# Planning Permit Officer Assessment Report

PA2402980, 173 Burke Road and 28 Hope Street, Glen Iris

Officer Assessment Report  
Development Approvals & Design

Figure 12 massing relationship to 163A Burke Road (circled)

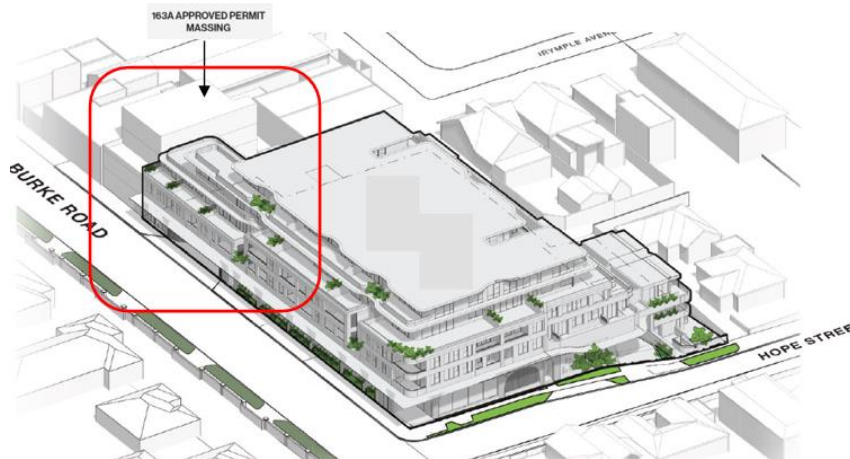
- 98. The southern boundary wall is considered acceptable within the commercial context and will provide the opportunity for future adjoining development to mirror this boundary form.
- 99. If the approved three storey development at 163A Burke Road is constructed, the proposal will also respond appropriately to this future context. The submitted urban context report notes that the proposal has been designed to account for future development of 163A Burke Road, with the upper form generally reflecting the adjoining proposed street wall and, above the two storey street wall, setting back the third storey in line with the 163A Burke Road upper form.

Figure 17 Massing Comparison (south-west corner circled)

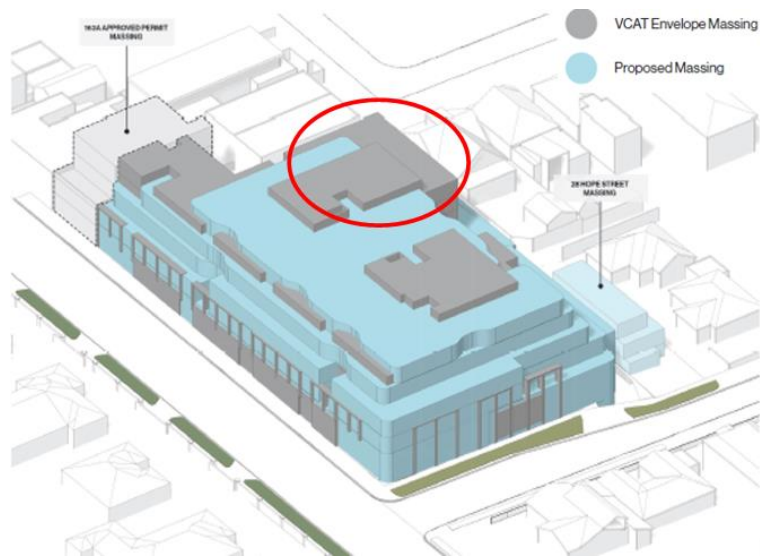
110. To Irymple Avenue the built form would be more exposed. The building has been substantially cut back from this interface compared with the proposal considered by the Tribunal. The prominent south-west corner is now more recessive, as follows:

- Level 1 western setback increased from 4m to 10m
- Levels 2 and 3 western setback increased from 7m to 15m
- Level 4 western setback increased from 10m to 18m.

Figure 20 southwest corner (turntable wall extent circled)

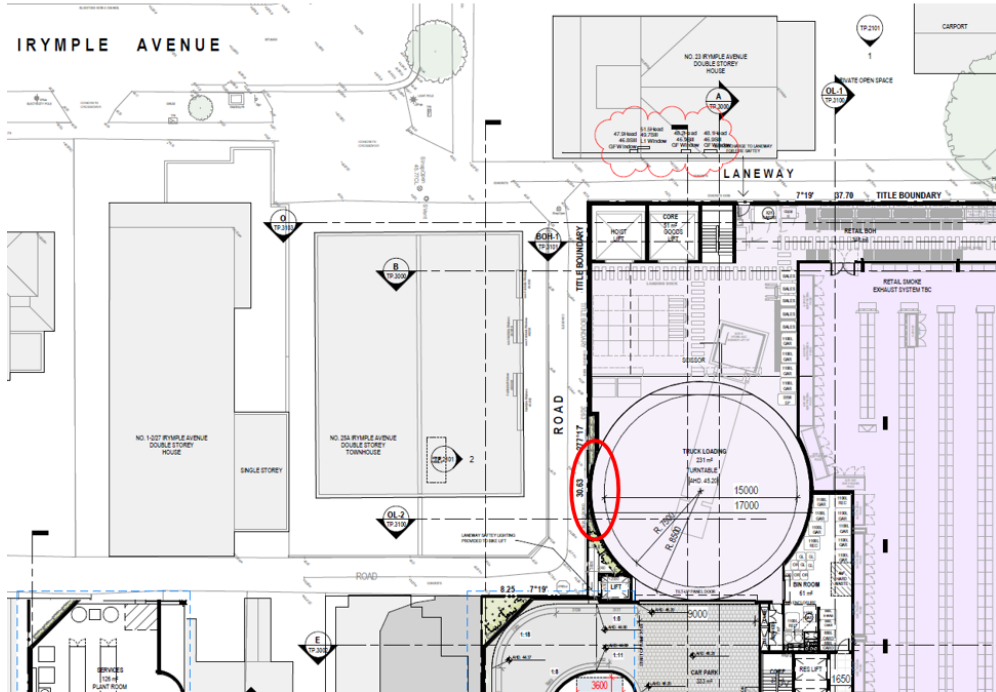
113. The south wall to the loading turntable would be higher but impact the boundary only to the extent of the turntable itself, flanked by small setbacks providing for landscaping to soften the visual impact. This is considered acceptable.

**Figure 23 Formal application plans 9am shadow**

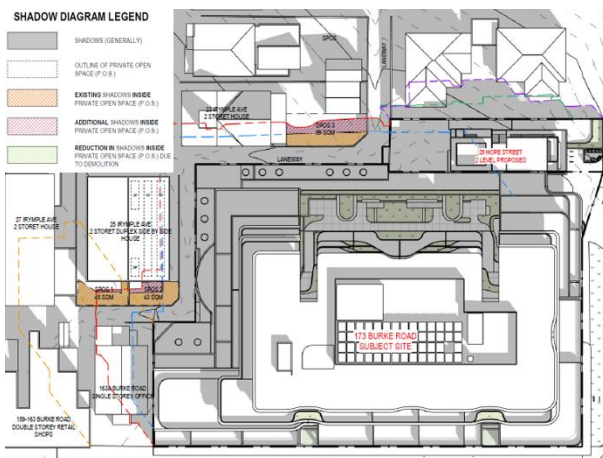
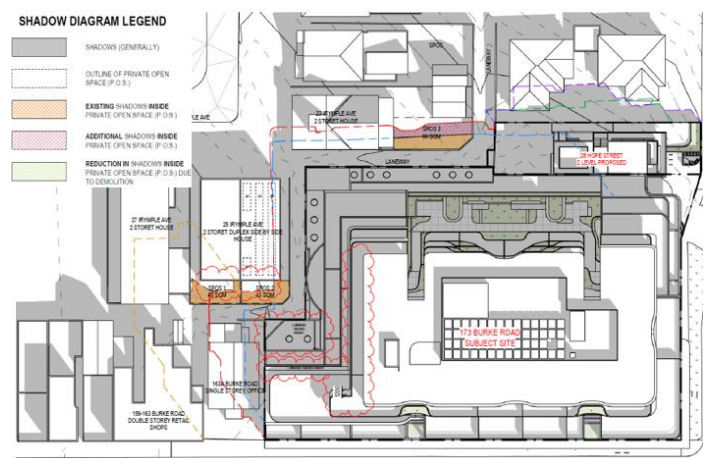
136. In response to objections, informally amended architectural plans were submitted showing a reduction to building mass toward the south-eastern corner of the site, to ensure that there will be no additional overshadowing to 25 and 25A Irymple Avenue at 9am. Specifically, changes include:

- Apartment 306 - reduction of the living room area and the terrace parapet line.
  - Apartments 405 and 406 - reduction to the depth of the southern terrace to by 200mm.

137. This is considered a positive change and is supported. It is recommended that the amended plans be formally substituted by way of permit condition.
